**CONCEPTUAL, BASIC and DETAIL DESIGN
ENGINEERING OF STYRENE PARK OFFSITE**

Document Title: Process Flow Diagram

Document No. : EI0127-HRC-VD-PR-PFD-002-R0

STYRENE PARK OFFSITE

VENDOR:			 			
PROJECT: STYRENE PARK OFFSITE						
DRAWING TITLE: Process Flow Diagram						
DRAWING NO.		REV.	SIZE	SCALE	SHEET	
E10127-HRC-VD-PR-PFD-002		RO	A3	NTS	3 of 4

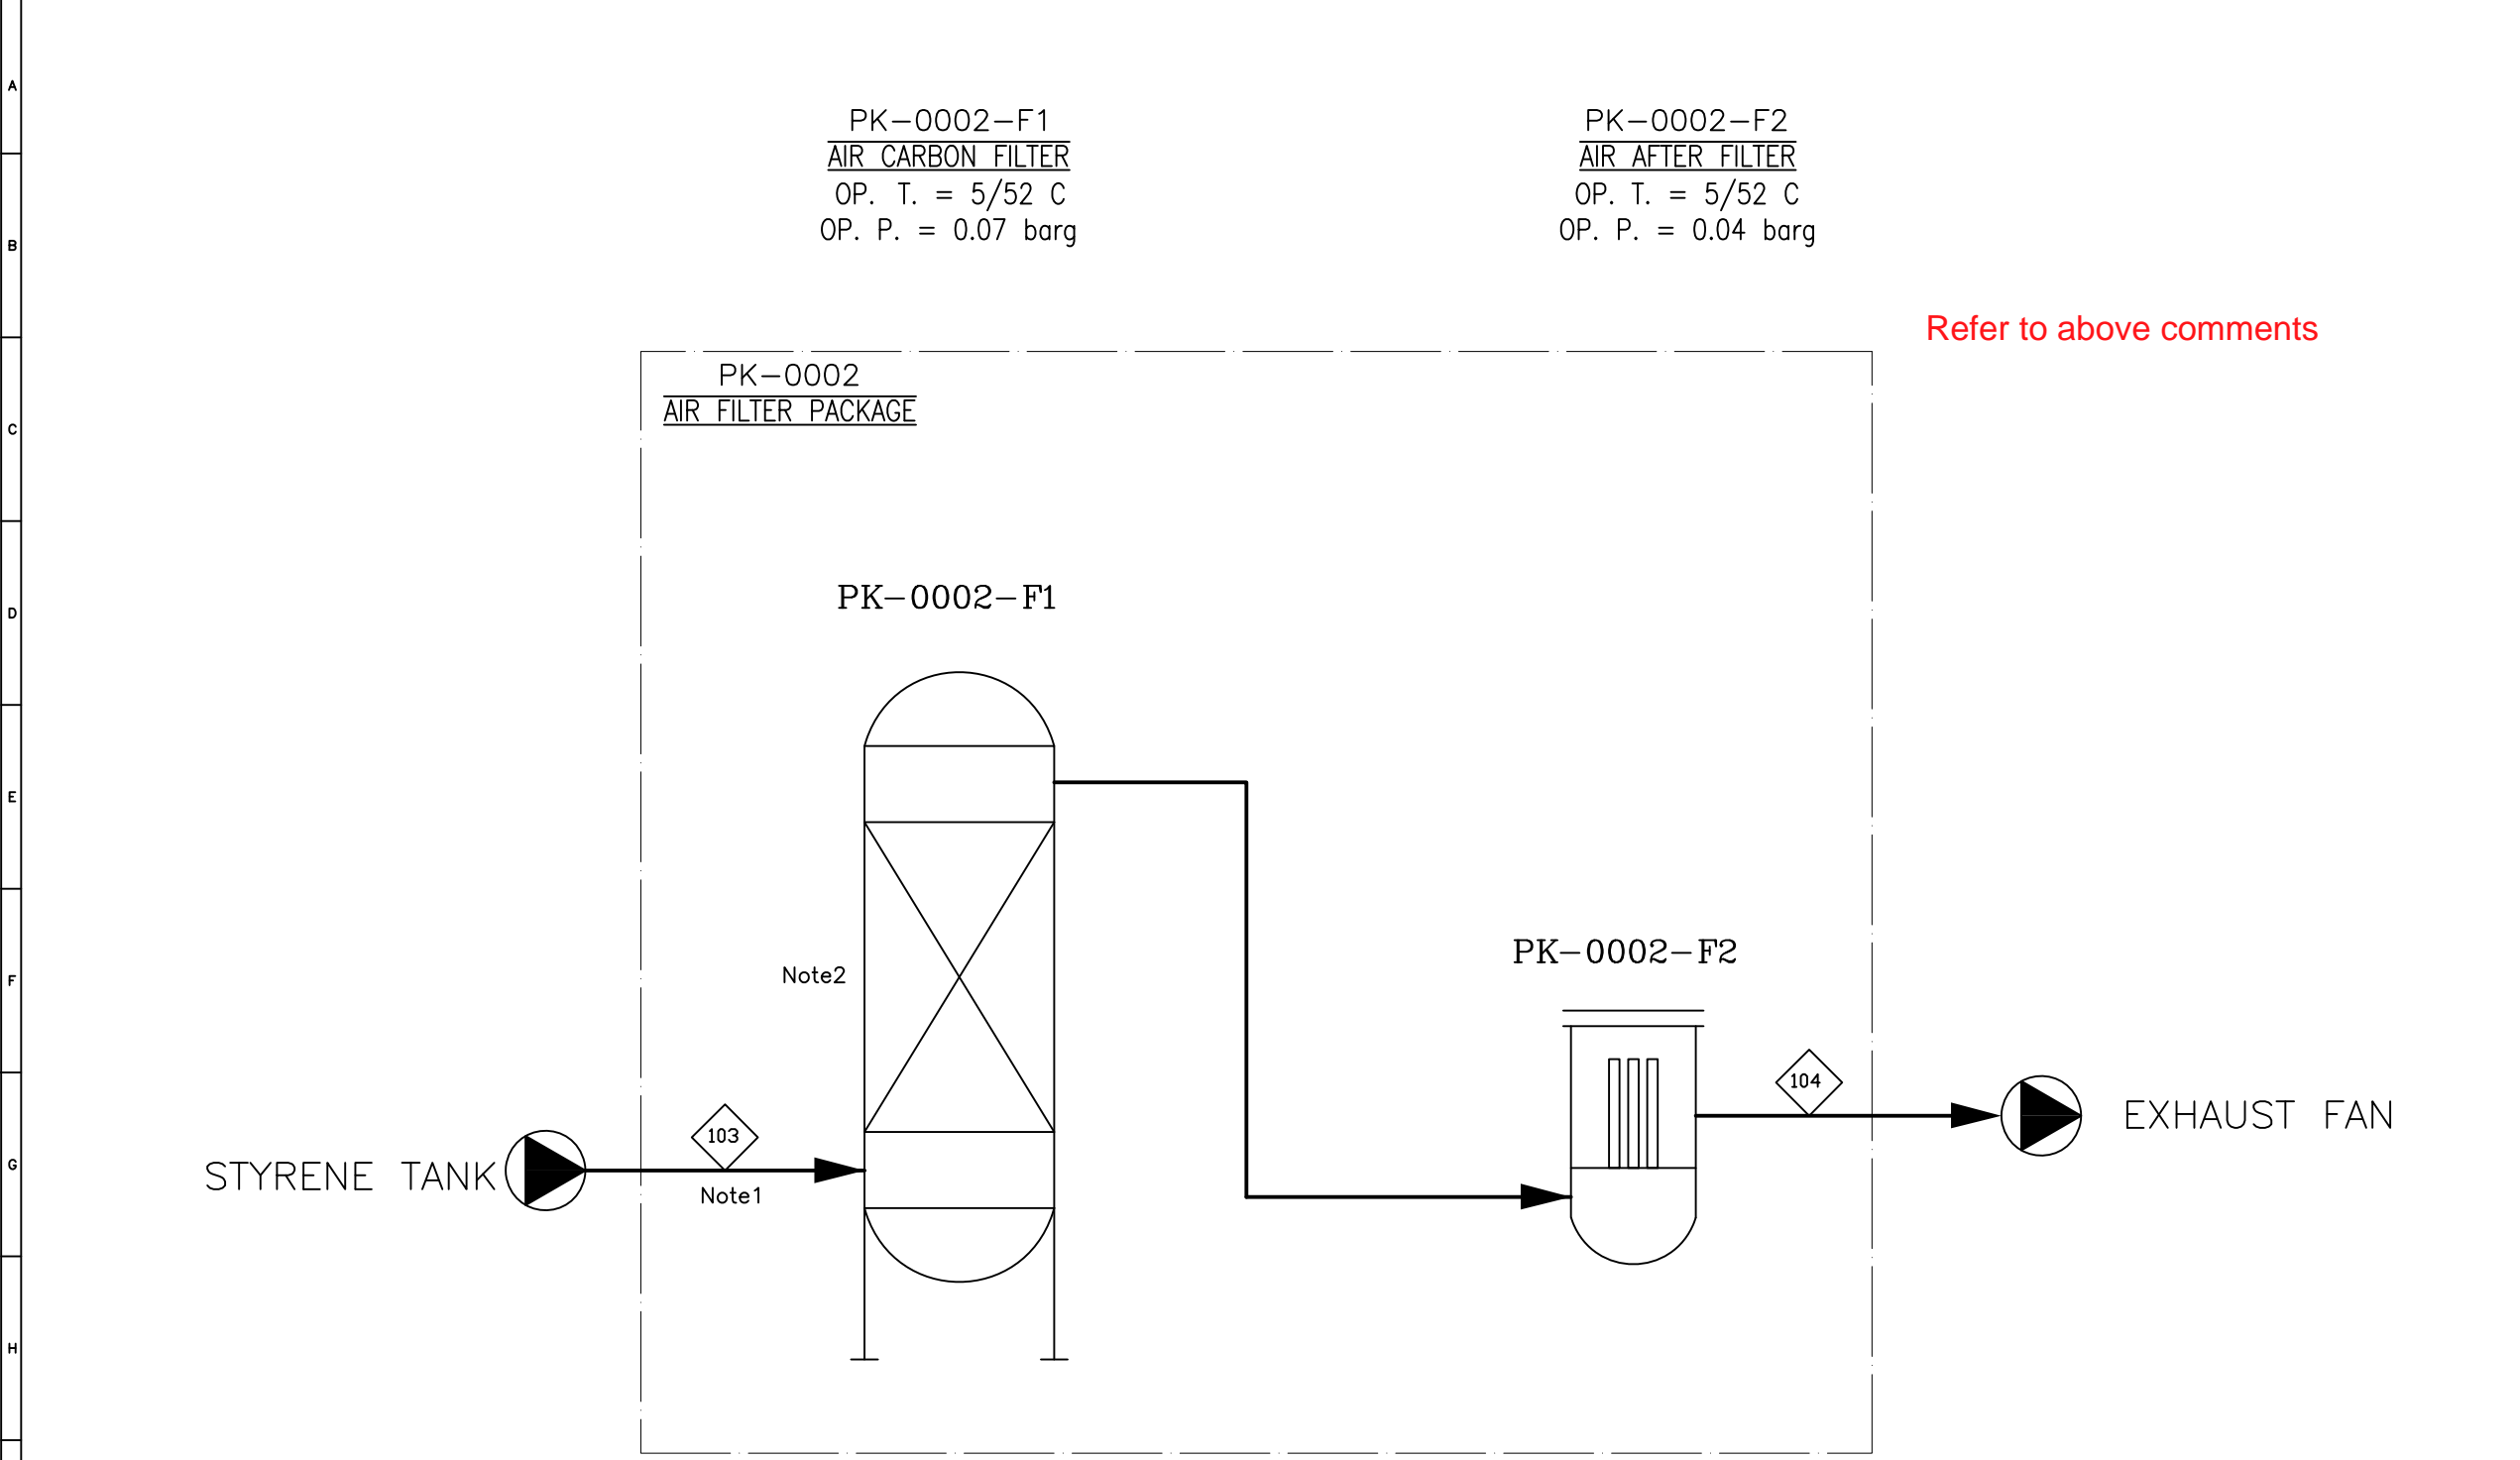
Tag numbers shall be according to project documents

Operating pressure shall be revised based on the "Process Duty Specification for Activated Carbon Package"
 HRCO: Noted, All data will be revised according to duty spec and project PFD.

Tags outside of the package battery limit shall be in accordance with the project P&ID/PFD
 HRCO: Noted, All data will be revised according to duty spec and project PFD.

This value has discrepancy with the "Process Duty Specification for Activated Carbon Package"
 HRCO: Noted, All data will be revised according to duty spec and project PFD.

Shall be deleted

Equipment location shall be according to final PFD of the project.

These values has discrepancy with the "Process Duty Specification for Activated Carbon Package"
 HRCO: Noted, All data will be revised according to duty spec and project PFD.

BINA logo shall be removed in all pages
 HRCO:Noted
